Job Name:	1 Henfaes Road, Tonna, Neath Port Talbot, SA11 3DX	Job N°:	IMA-24-077
Date:	22 nd June 2026	Client:	Emily Byrne

NEATH PORT TALBOT COUNTY BOROUGH COUNCIL – HIGHWAYS OBSERVATIONS

Planning Application No: 2/3/25/0842/00

IMA Designer's Response to Highways Observations

Client	Emily Byrne	Dwg No.	1566 026 E
Project	Tyn Yr Heol, Neath	Scale	1:200 @ A1
Title	Site Plan as Proposed (Ground Floor Plans)	Date	NOV.24
		Drawn	PS Checked KLM

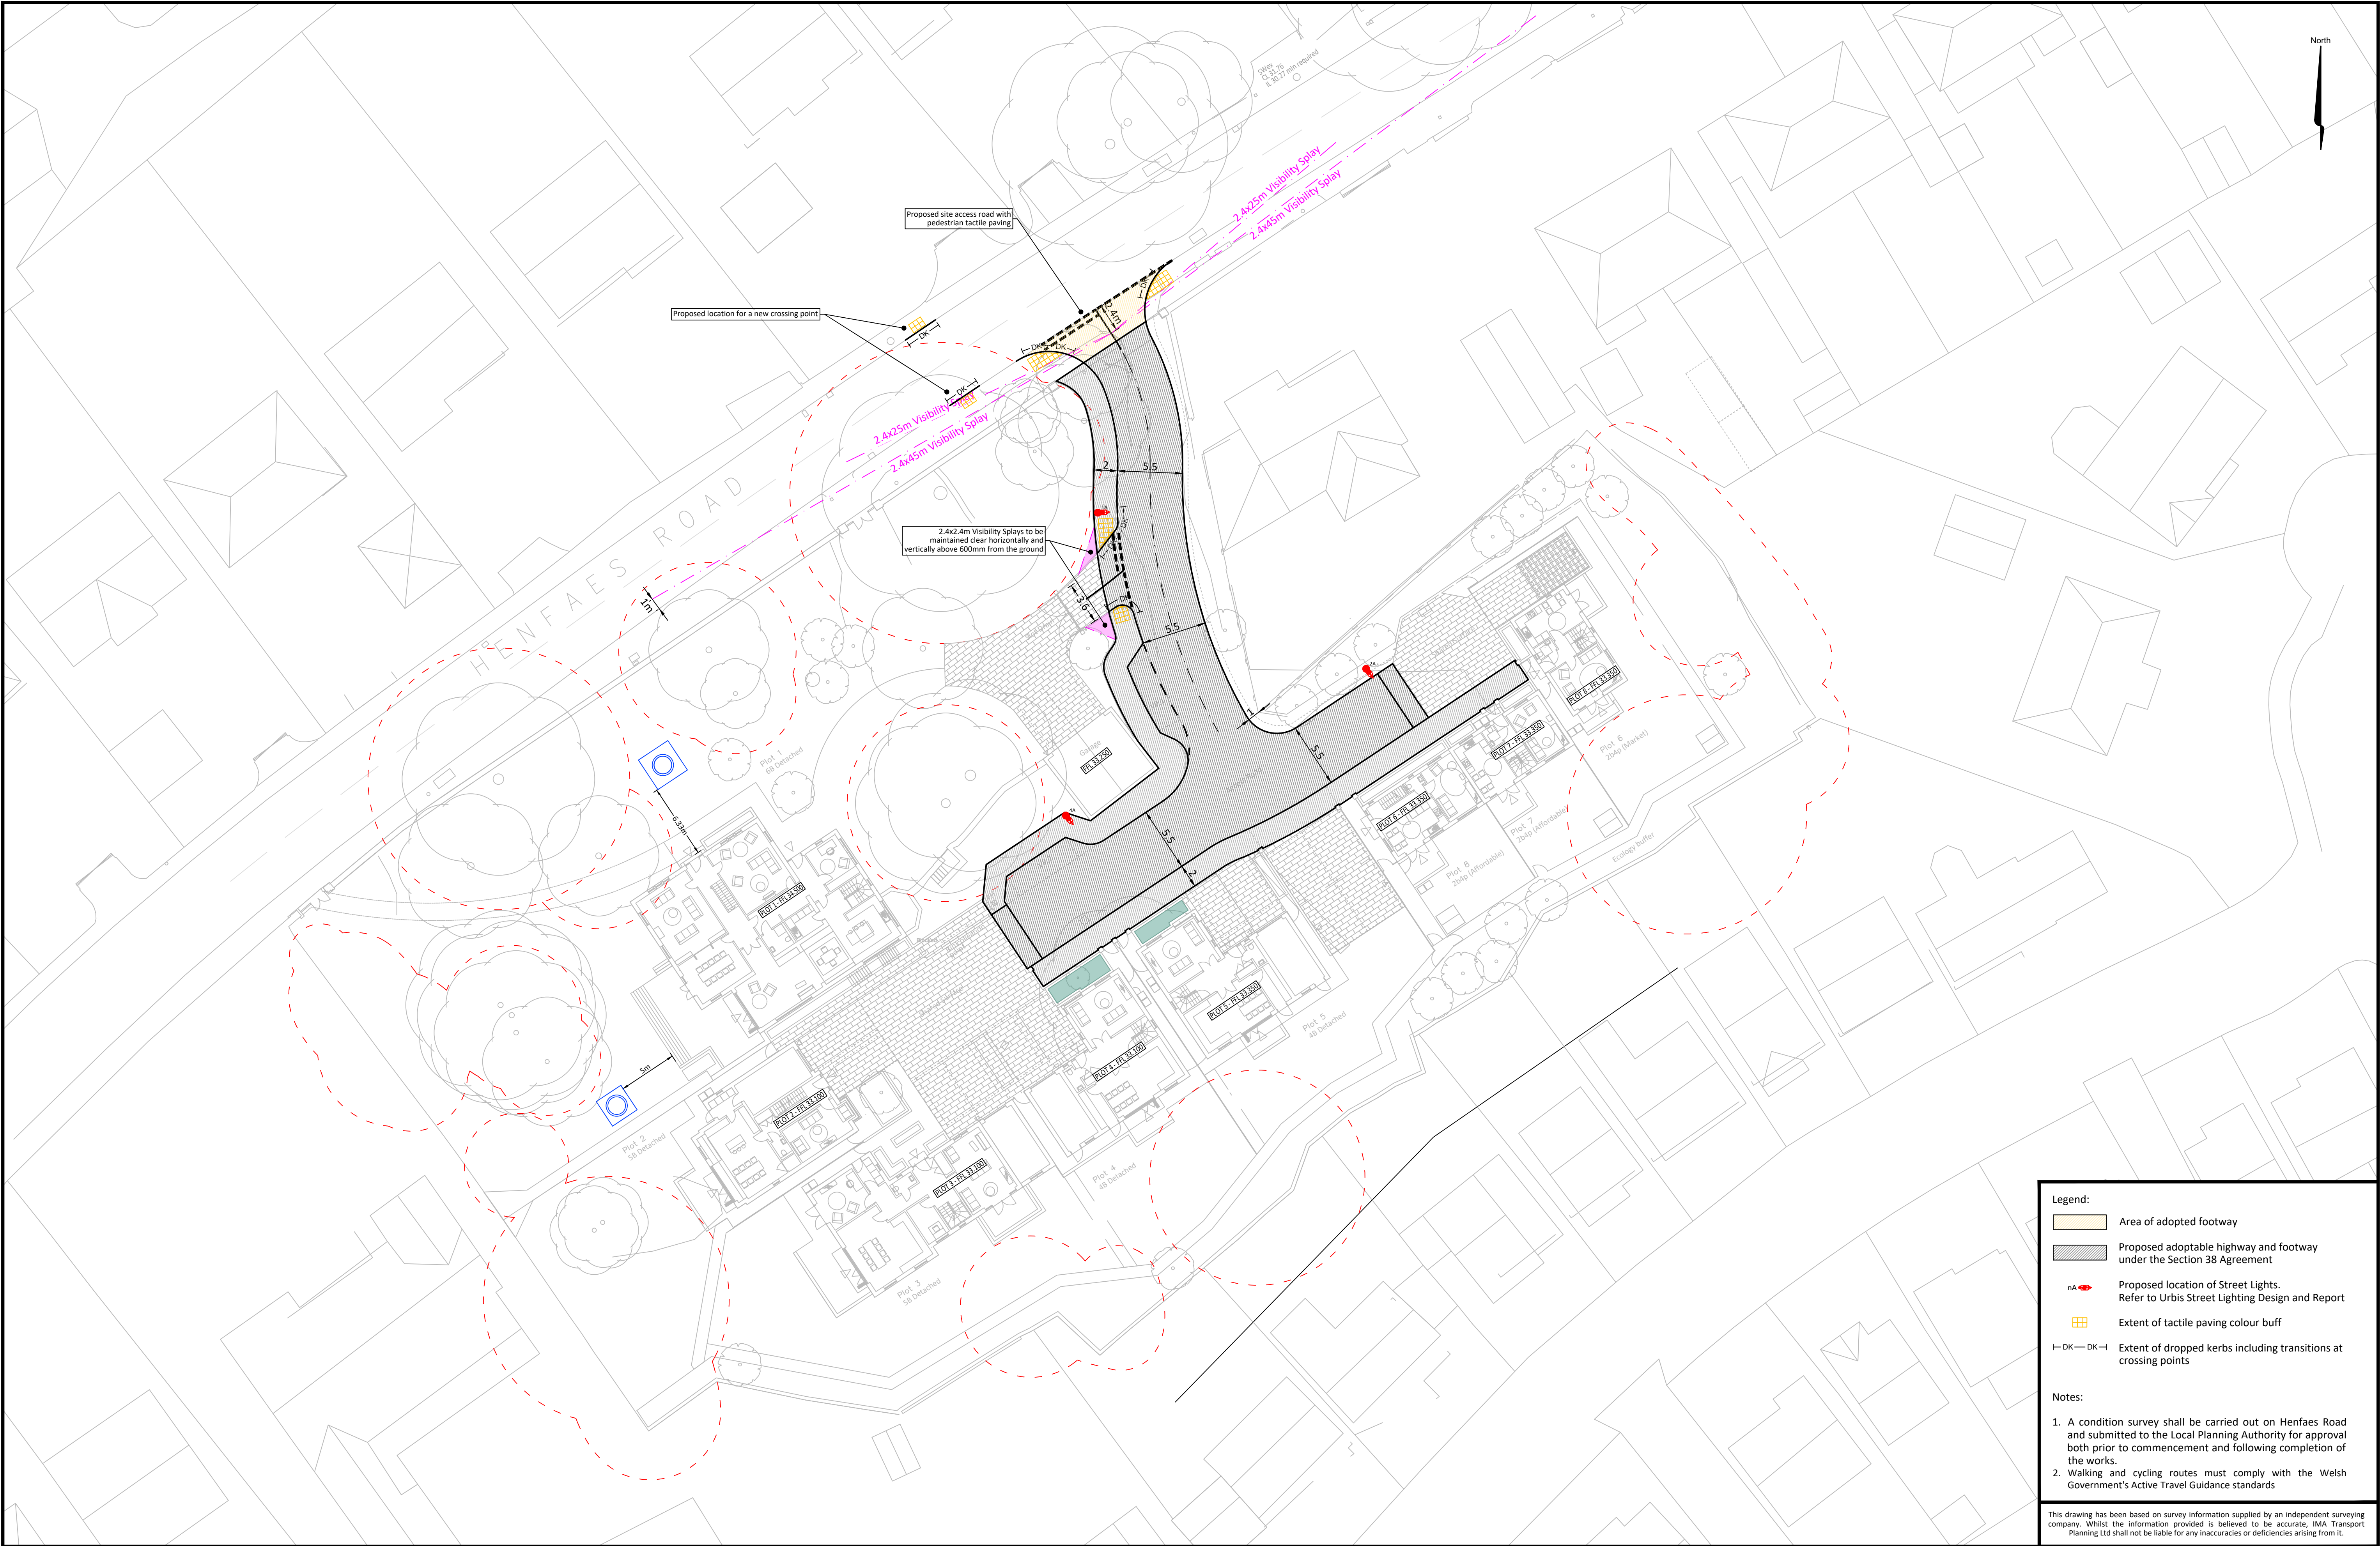
1.1 *As per NPTCBC's Parking Standards SPG, Residential Parking Areas are to achieve the below dimensions per property:*

- *Single Car Parking Bay - 6m x 3.6m (not achieved at Plots 6,7 & 8)*
- *Double driveway - 6m x 6.2m*
- *Triple driveway - 6m x 8.8m*

Whilst we understand that 6 meter length parking bays may not be achievable on this site, given the area constraints, we would maintain that the widths expressed above should be achieved to promote ease of use and access. Furthermore, all parking bays that do not achieve a 6m length, shall be designed to achieve 4.8m length and shall front the footway to allow appropriate access to car boot spaces and promote pedestrian safety.

- 5.1 A bin collection point/ storage area shall be demonstrated for Plot 6 on drawing 1566 026 C. Authority Recycling and Refuse vehicles will not travel onto private or shared driveways to make kerbside collections. For Shared/ Private Drives all bin collection points must be sited to allow for kerbside collection adjacent to the adopted highway, whilst maintaining vehicular visibility onto the publicly adopted highway. Please note that NPTCBC recommend a maximum walking distance of 25m for residents to these Bin Store Areas and will not expect our Refuse Personnel to travel further than 5m from the Adopted Highway to make these collections.*

Please note that your comment above has been incorporated in the revised AEvans' drawing 1566 026 E Site Plan as Proposed included in this report.

Bin collections points have been incorporated into the layout to facilitate kerbside collection in accordance with the requirements and are indicated on drawing 1566 026 E Site Plan as Proposed.
